CORNER FLEXURE

3 DEC 2003

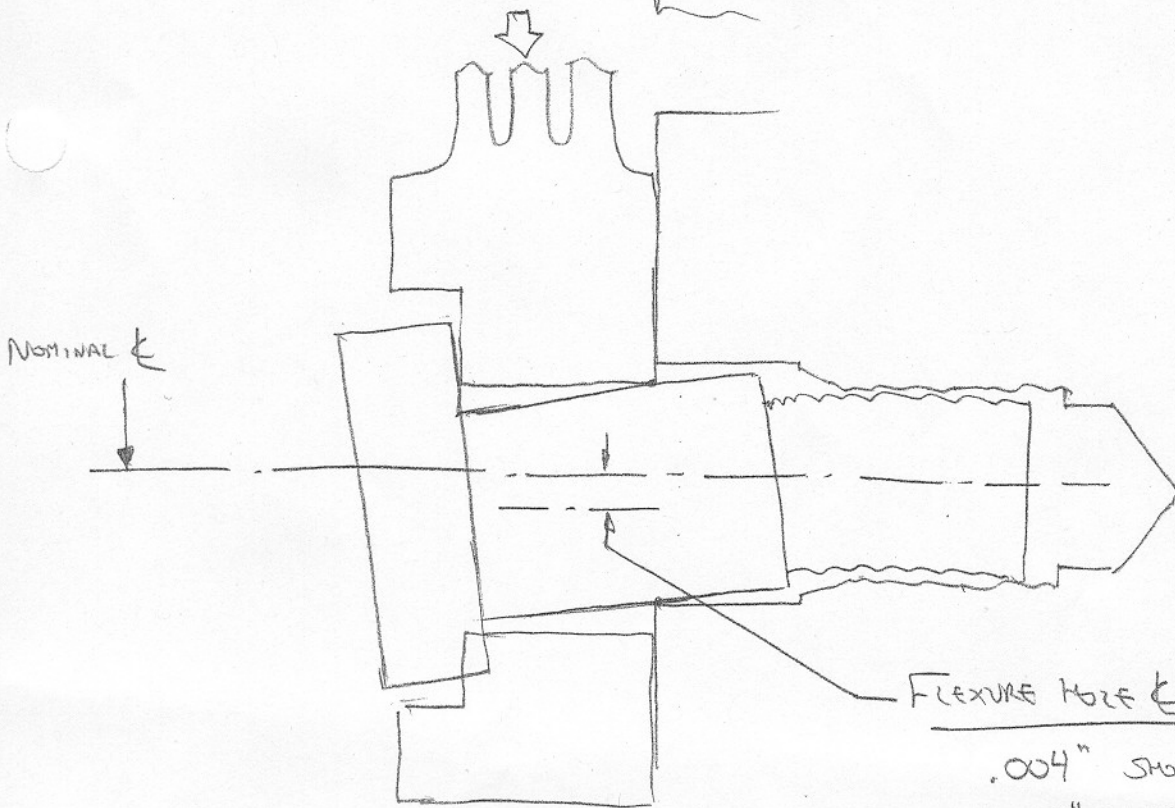
$16.5 \pm .05$ mm
($.650 \pm .002$ ")
DS-00422-3 (3-BURR)

$2.5 \pm .1$ mm
($.0984 \pm .004$ ")
DS-00422-3 (3-BURR)

FLEXURE HOLE & OFFSET:

- $.004$ " SHOULDER RATTLE IN FLEXURE
- $.001$ " OVERSIZE OF FLEXURE HOLE
- $.004$ " SHOULDER BOCT BENDING IN C-BORE HOLE

$.009$ " OR $\pm .0045$ "

CORRESPONDS TO
46 HZ OSCILLATION

① SHOULDER BOLT CLEARANCES

- FIT IN FLEXURE AND GRID ARE TOO SLOPPY
- THIS ALLOWS RATTLING WHICH BENDS SHOULDER BOLT AT THREADS AND RESULTS IN LOSS OF PRE-LOAD

② FLEXURE BLADE PINNING TO ^{TRAY} CORNER BRACKET

- BLADE SLIPS INTO BRACKET SUT WITH A MILD INTERFERENCE FIT WHICH CANNOT BE COUNTED ON TO RESTRAIN IT
- 2 PINS LOCATE THE BLADE AND CARRY ALL SHEAR LOADS.
- ACCORDING TO DRAWING TOL'S, PIN FIT INTO BLADE IS LOOSE: $.002''$ RADIAL CLEARANCE. THIS WOULD ALLOW ROTATION OF THE BLADE WRT THE BOTTOM TRAY

③ FLEXURE BLADE 45° MOUNTING SURFACE

- FLEXURE MOUNTS TO GRID ON 45° CHAMFER IN GRID CORNER AND FLEXURE BLADE BASE
- WIDTH OF LAND ON BLADE ONLY PROVIDES $\pm .008''$ CLEARANCE TO EDGE OF LAND ON GRID, ASSUMING PERFECT FORM AND FIT
- WHEN FEATURE TOL'S ARE ADDED, THIS COULD CAUSE FLEXURE TO RIDE UP ON SIDE OF GRID
- THERE IS INDICATION OF WEAR MARKS ON VIBE TEST STAND SUGGESTING THAT THIS HAPPENED

REC → TIGHTEN FITS CONSIDERABLY INTO GRID AND/OR TORQUE SHOULDER DOWN TO GRID TO PRODUCE CANTILEVERED PIN

REC → TIGHTEN FIT IN FLEXURE TO PREVENT RATTLING. USE TAPER OR EXPANDABLE FEATURE IF NEEDED

REC → MATCH-REAM THESE HOLES FOR AN INTERFERENCE FIT

REC → REDUCE HOLE DIAMETRAL TOLERANCE AND NOM HOLE SIZE FOR INTERFERENCE FIT

REC → REDUCE WIDTH OF BLADE BASE TO PROVIDE AMPLE CLEARANCE TO GR

④ VIBE TEST FIXTURE

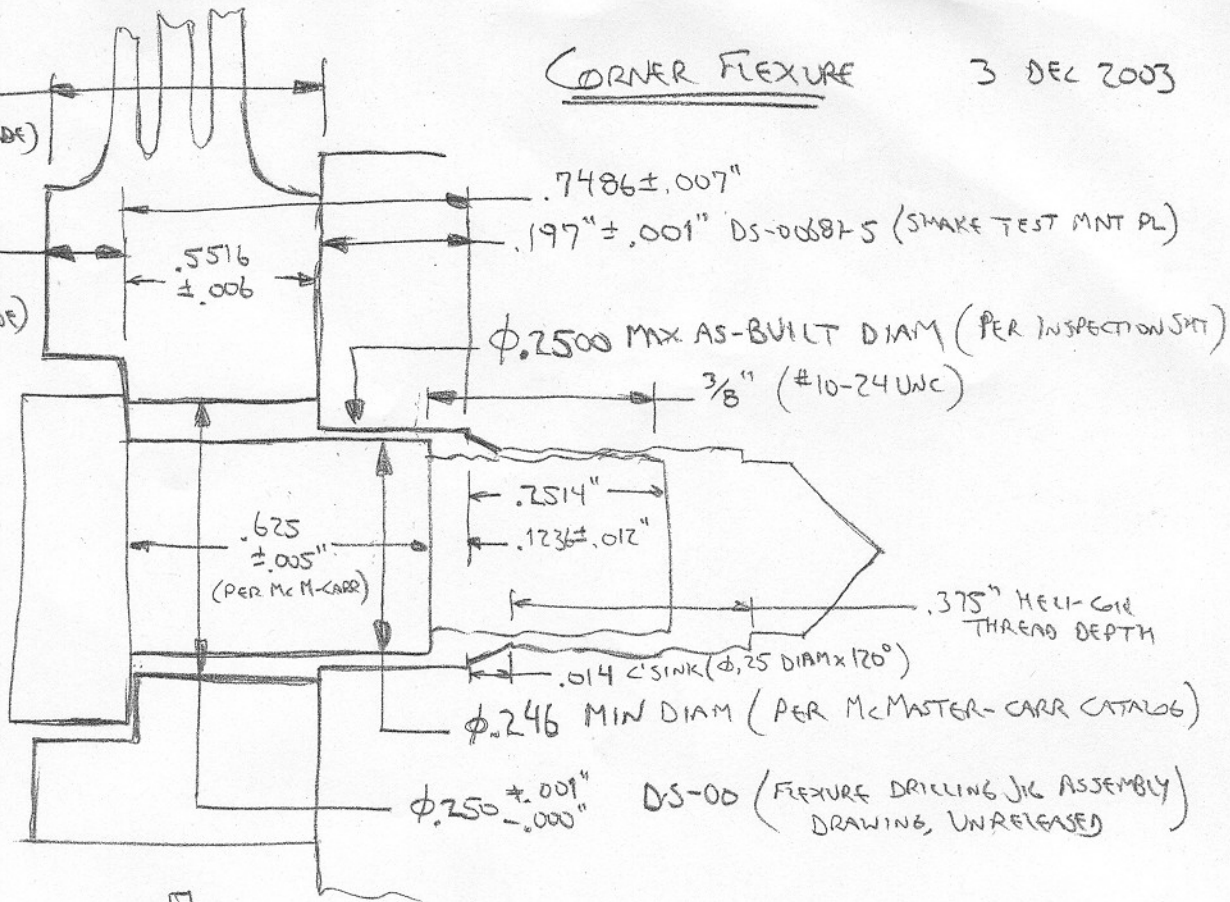
- FIXTURE WAS NOT BUILT TO PRINT, BUT TO VERBAL INSTRUCTIONS, SO THIS CAN'T SERVE AS A TEMPLATE FOR THE GRID

- TOL'S ON DRAWING APPER LOOSE AND DRAWING HAS CLEARLY NOT BEEN CHECKED (DOUBLE-DIMENSIONING, ILL-DEFINED DATUMS AND DIM'S, ETC)

REC → REVISE DRAWINGS TO MATCH REQUIRED DIMS AND TOLS, SO IT CAN BE USED AS A TEMPLATE FOR GRID FABRICATION

REC → CHECK THIS AGAINST BOTTOM TRAY DRILLING FIXTURE TO ENSURE THAT INTERFACES FIT-UP AS EXPECTED
